OAK CREEK SUBDIVISION
CITY OF ROCHESTER HILLS SITE PLAN REVIEW SUBMITTAL
3249 AND 3271 S. LIVERNOIS ROAD
ROCHESTER HILLS, OAKLAND COUNTY, MICHIGAN
Wetland, Watercourse, and Natural Feature Setback Impacts

**Subject: Oak Creek Subdivision
3249 & 3271 Livernois
(Sidwell Nos. 70-15-324-101-053 & -055)
Site Plan Review #5
Site Plans dated February 10, 2025
ASTI File No. A25-1482.05**

ASTI has reviewed the site plans, dated February 10, 2025 (Current Plans), for conformance to the Wetland and Watercourse Protection Ordinance and the Natural Features Setback Ordinance and offers the following comments for your consideration.

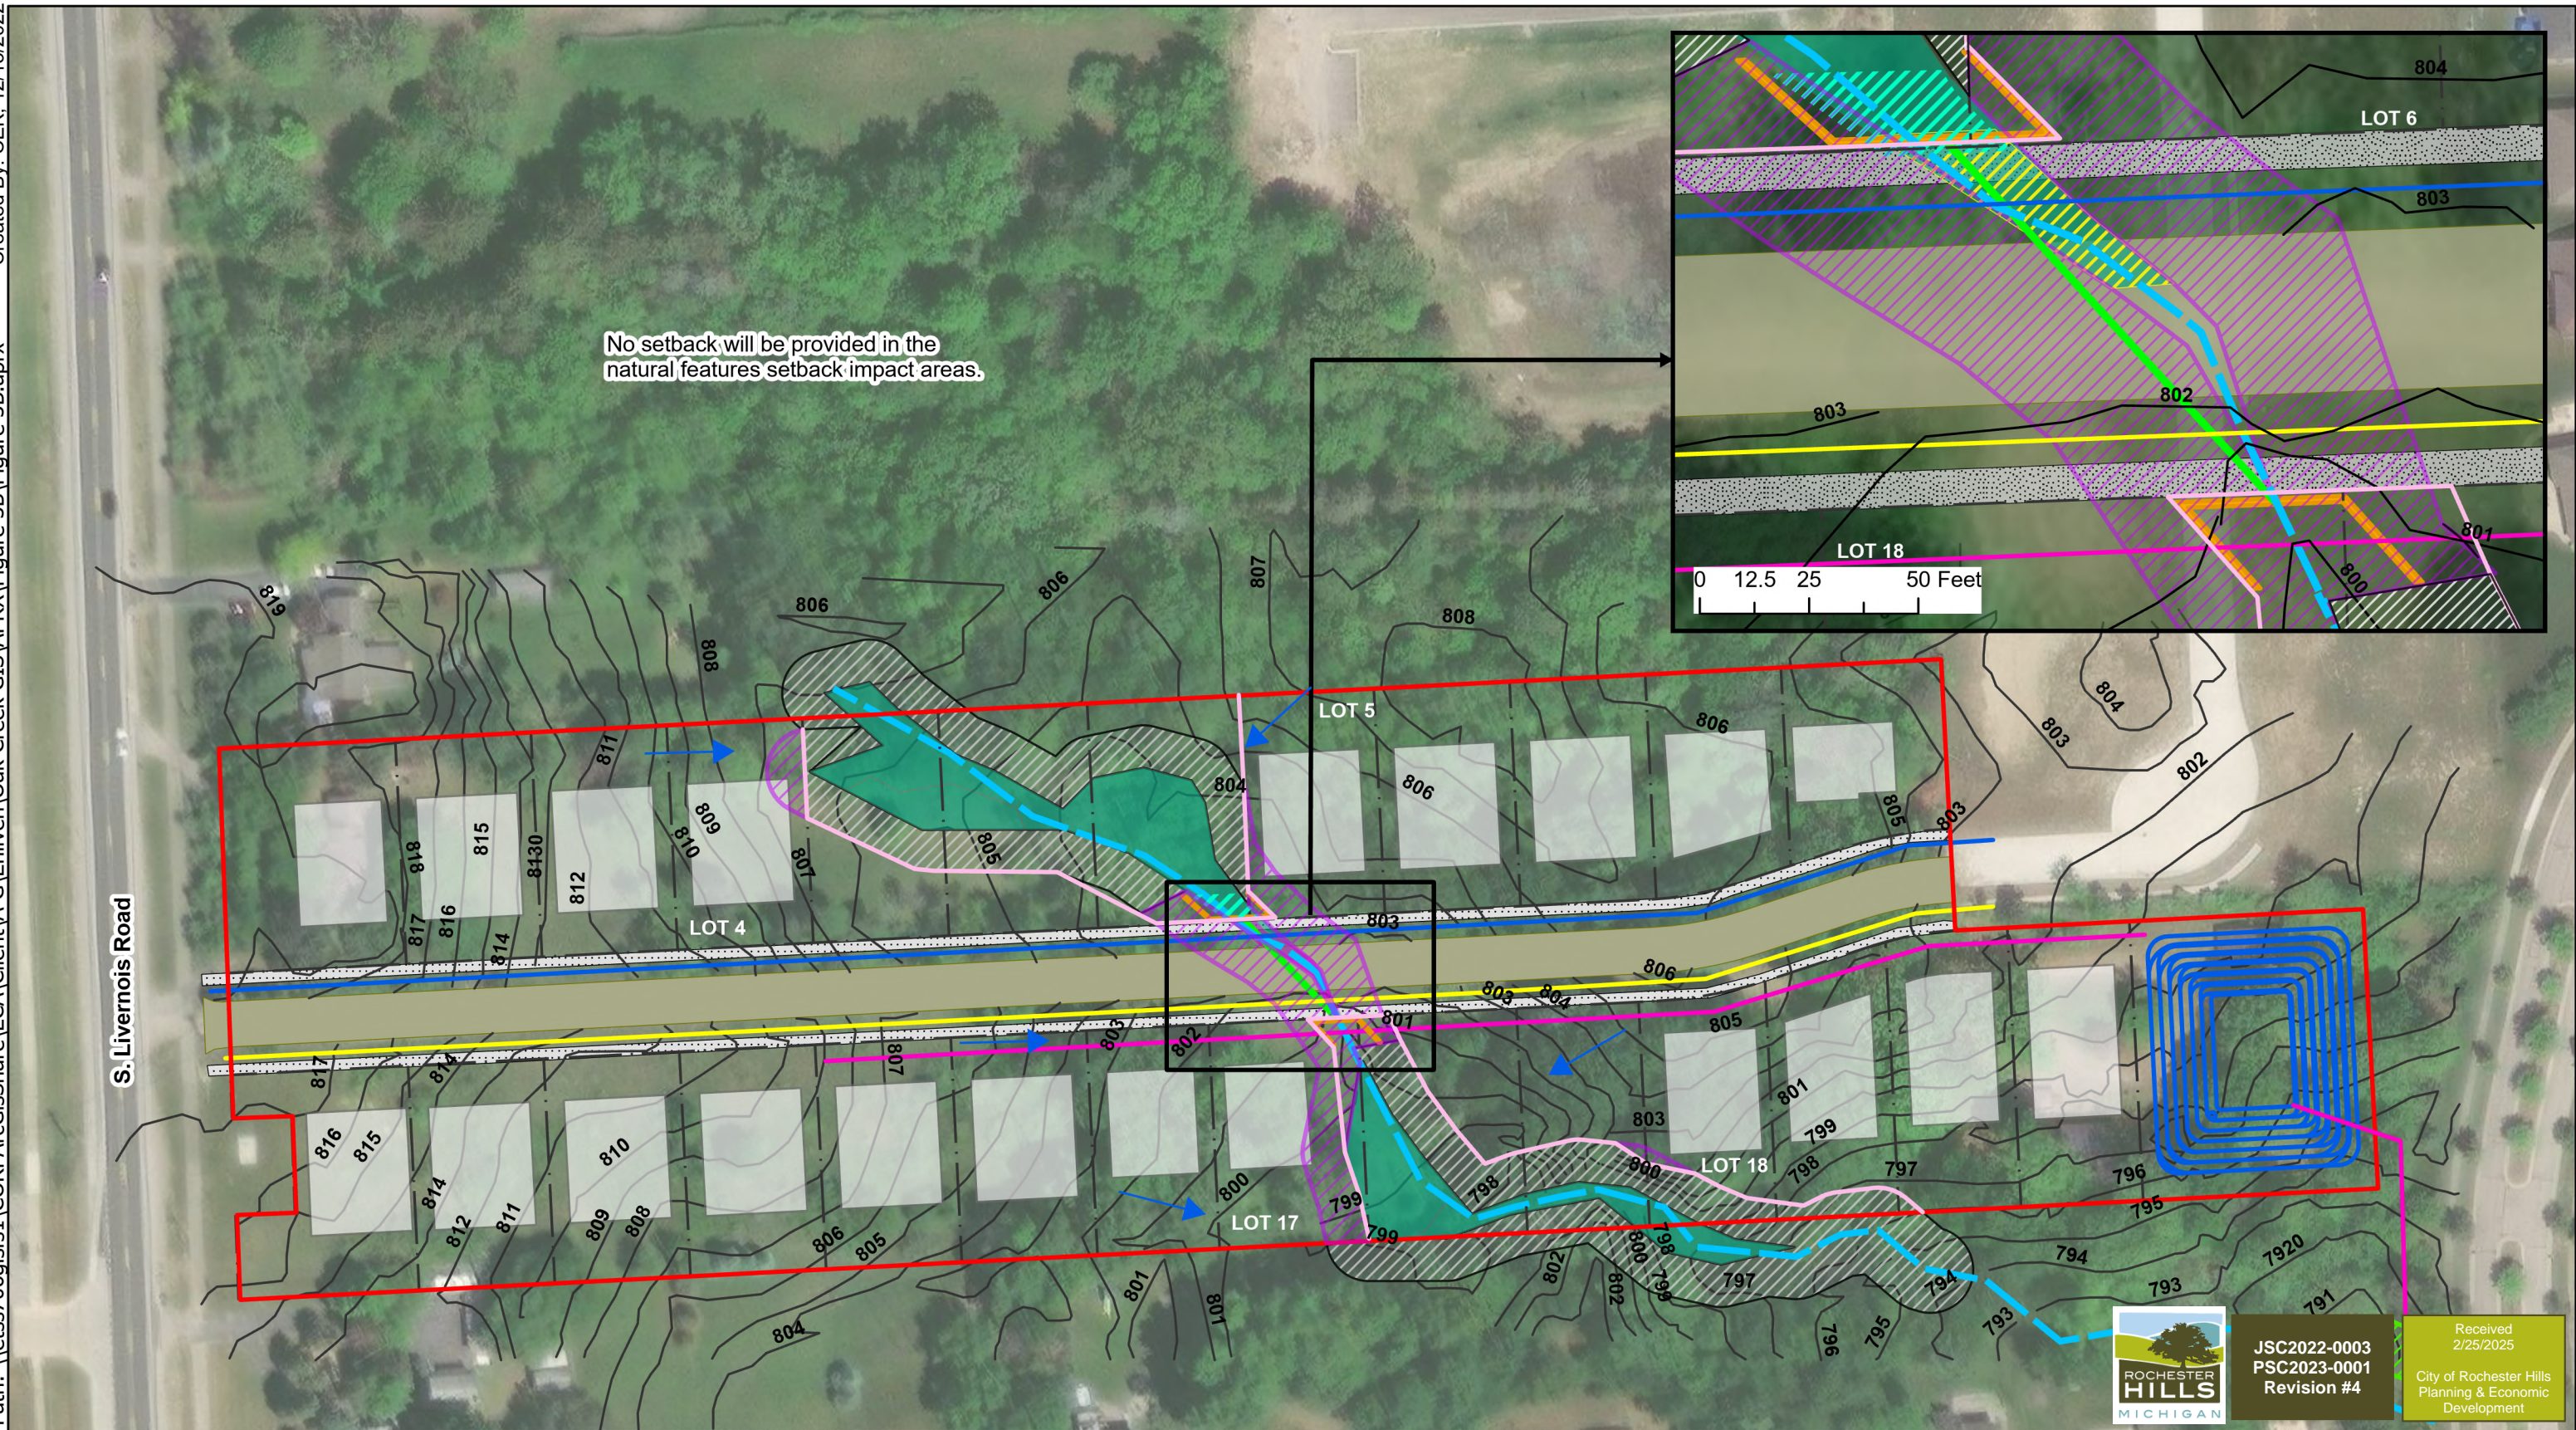
- a. Sheet C3.1 shows that 355 ft² of temporary impacts and 417 ft² of permanent impacts to Wetland A will occur and 85 linear feet of permanent impacts to the unnamed watercourse will occur from the construction of the proposed access road and from the installation of a proposed culvert beneath the road to replace the existing culvert/bridge. ASTI recognizes that constructing the proposed access road in the same area as the existing driveway is the most prudent area to do so. Moreover, installing a proposed drainage conveyance in the area of the existing culvert/bridge is also the most prudent location for this action. As stated in previous reviews, ASTI recommended the construction of a small span bridge or box culvert in this area that minimizes permanent impacts to Wetland A. This

5. **Natural Features Setback (§21.23).** This Section establishes the general requirements for Natural Features Setbacks and the review criteria for setback reductions and modifications.
 - a. All Natural Features Setbacks and all impacts to Natural Features Setback stated in linear feet are now shown on Sheet C3.1 of the Current Plans, which is to ASTI’s satisfaction.

- b. Sheet C3.1 shows 73 linear feet of permanent Natural Features Setback impacts will occur from the construction of Lot 4. These impacts are small and the Natural Features Setback in this area is generally of low quality, being dominated by common lawn species such as Kentucky blue grass (*Poa pratensis*), heal-all (*Prunella vulgaris*), and clover (*Trifolium* spp.). Therefore, ASTI recommends the City allow for these impacts.

- c. Sheet C3.1 shows 284 linear feet of permanent Natural Features Setback impacts will occur from the construction of Lot 17. The Natural Features Setback in this area is comprised of upland scrub/shrub/old-field and is of low to medium quality. The tree canopy layer was moderate and was comprised of the common native species of box elder and the non-native species crack willow (*Salix fragilis*) and multiflora rose (*Rosa multiflora*), generally in equal distribution. The shrub layer was thick and was dominated by the common native species of box elder (saplings) and staghorn sumac (*Rhus typhina*). The herbaceous layer was moderate and was dominated by Kentucky blue grass and the common native species of red raspberry (*Rubus ideaus*) and woodbine (*Parthenocissus inserta*). Overall, the Natural Features Setback in this area is comprised of native and non-native species in equal distribution (50% and 50%, respectively) and is of medium to low quality. Moreover, the impacts are small, do not impact the entire width of the Natural Features Setback, and split rail fencing is proposed for the remaining Natural Features Setback in this area as a barrier. Therefore, ASTI recommends the City allow for these impacts.

Sheet C3.1 shows 150 linear feet of Natural Features Setback will be permanently impacted from the construction of the proposed access road, sidewalk, and associated utilities. The access road, which is required to gain adequate access to the eastern portion of the property, is planned in an area that minimizes natural feature impacts. Moreover, the Natural Features Setback in this area is of low quality and function, being comprised of common lawn species. Thus, ASTI recommends the City allow for Natural Features Setback impacts in this area. This must be specifically noted on final plans for the development.

- d. Sheet C3.1 shows 140 linear feet of Natural Features Setback will occur from the construction of Lot 5. The Natural Features Setback in this area is forested and dominated by generally young trees of the common native species of shagbark hickory (*Carya ovata*), white oak (*Quercus alba*), and linden (*Tilia americana*). The shrub layer was sporadic and was comprised of the common native species of shagbark hickory and green ash, as well as the non-native species of glossy buckthorn and honeysuckle (*Lonicera tatarica*), generally in equal amounts. Herbaceous coverage was sparse at the time of the inspection and was generally dominated by the common native species of woodbine and poison ivy. The Natural Features Setback in this area was dominated by common native species (75%) with significant inclusions of non-native species (25%). Due to the higher percentage of native species within the Natural Features Setback in this area, it should be considered a medium quality buffer to Wetland A and impacts should be minimized to the greatest degree possible. However, the impacts are small, and ASTI recommends the City allow for these impacts subject to approval by the City's Parks and Natural Resources Department concerning tree removal activities proposed in this area. A split rail fence is shown alongside the remaining Natural features Setback in this area, which extends to the northern property boundary. This is to ASTI's satisfaction.

- e. Sheet C3.1 shows 45 linear feet of Natural Features Setback will occur from the construction of Lot 18. The Natural Features Setback in this area is forested and dominated by a mix of young to mature trees of the native species of shagbark hickory, ironwood (*Ostrya virginiana*), red oak (*Quercus rubra*), and black cherry (*Prunus serotina*). The shrub layer was very sparse and was dominated by the native species of white oak, red oak, and black cherry with minor inclusions of the non-native species honeysuckle. The herbaceous layer was sporadic and was dominated by the common native species of woodbine and poison ivy. The Natural Features Setback in this area was dominated by native species (95%) with slight inclusions of non-native species (5%). Due to the high percentage of native species within the Natural Features Setback in this area, it should be considered a high-quality buffer to the unnamed watercourse in this area, and impacts should be minimized to the greatest degree possible. However, the impacts associated with Lot 18 are small, and ASTI recommends the City allow for these impacts subject to approval by the City's Parks and Natural Resources Department concerning tree removal activities proposed in this area. A split rail fence along the remaining Natural Features Setback boundary from Lot 18 to the proposed access road. This action, along with the installation of the signage described above, should protect the remaining Natural Features Setback in this area. This is all shown on the Current Plans to ASTI's satisfaction.

- f. Sheet C3.1 does not indicate that any Natural Features Setback impacts will occur from the construction of Lots 19 and 20. Moreover, the Current Plans now show the Natural Features Setbacks associated with Lots 19 and 20 with split rail fencing and signage to protect against unplanned future impacts. This is to ASTI's satisfaction.
- g. The Current Plans show that approximately 25 linear feet of Natural Features Setback will be temporarily impacted from the installation of the outlet pipe associated with the on-site watercourse and detention basin drainage system off-site.

The applicant responded to this assertion per the following: “The project proposes 85 linear feet of 36-inch reinforced concrete pipe (RCP) to replace the existing culvert at the access drive. The existing culverts are dual 12-inch corrugated metal pipes that are at least half full of sediment. The proposed RCP will meet the Michigan Department of Environment, Great Lakes, and Energy (EGLE) minor permit standards for new or replacement culverts and bridge structures that are 100 feet or less in length. The proposed culvert will span the 3-foot-wide bankfull width of the stream, will be set on the same slope as the deepest part of the riffle channel measured from the upstream riffle to a downstream riffle outside of the effects of the existing culvert, will align with the centerline of the stream at both the inlet and outlet ends, and the invert elevation will be buried six inches (1/6 of the bankfull width). Since the proposed culvert will span the bankfull width of the stream and will be buried, it will allow for passage of wildlife, prevent erosion upstream and downstream, provide sufficient hydraulic capacity during storm events, and reduce the risk of flooding. The proposed impacts to Wetland A as a result of the culvert installation would be the same for the proposed 36-inch RCP culvert as they are for a small span bridge or box culvert. The permanent impact to Wetland A will be a result of installing the culvert in the wetland, and associated fill and grading for the proposed road and sidewalk that will be placed above the culvert. The installation of a box culvert or small span bridge would also permanently impact Wetland A for the road and sidewalk.” After review of this information, it is ASTI’s opinion the applicant has provided an adequate analysis for installing the culvert as proposed on the Current Plans.

ASTI recommends the City approve the Current Plans on the condition that the items in Comment 5.d are addressed on final plans.
